ADDENDUM #: 01
PROJECT: Family & Children's Services Roof Repair & Re-coat
DATE: 3/2/2023
ISSUED BY: Ryan Bartow bartowr@mendocinocounty.org

Project:
 Family & Children's Services
 Roof Re-Coat
 727 South State Street
 Ukiah, Ca 95482

Project No.
 CI 066

A005

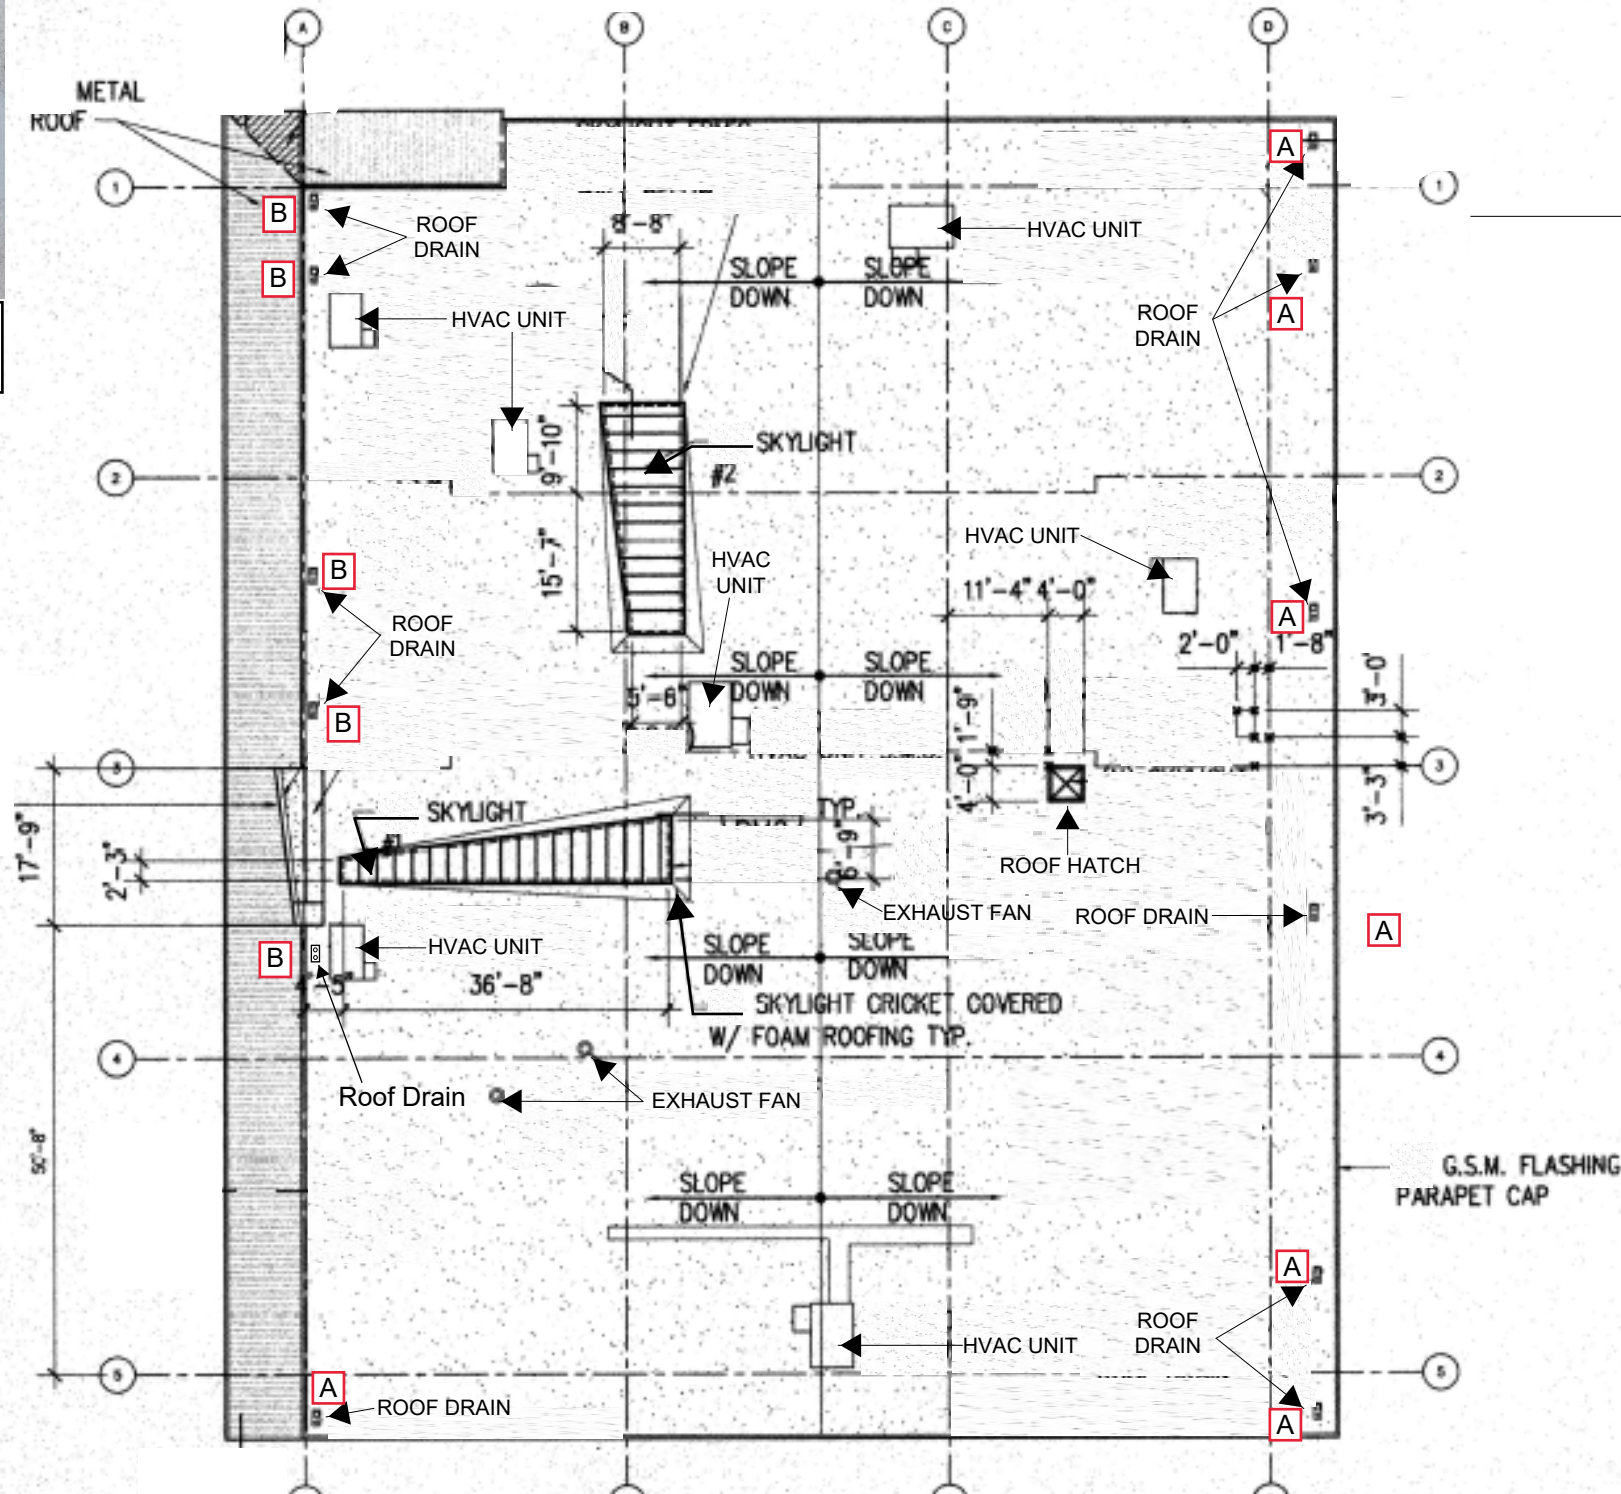
1. **Q:** Section 00650 Construction Site Storm Water Policy requires a plan to divert roof wash water from the Storm Water System. How is the building roof drain system tied into the Storm System?
- A:** See attached Roof Drainage Plan Sheet 005.

Roof Drain Notes:
 A: Roof Drain outlet is located on face of wall at ground level. See Examples
 B: Roof drain outlet is believed to feed directly into the city storm water system*
 *Contractor Shall Verify
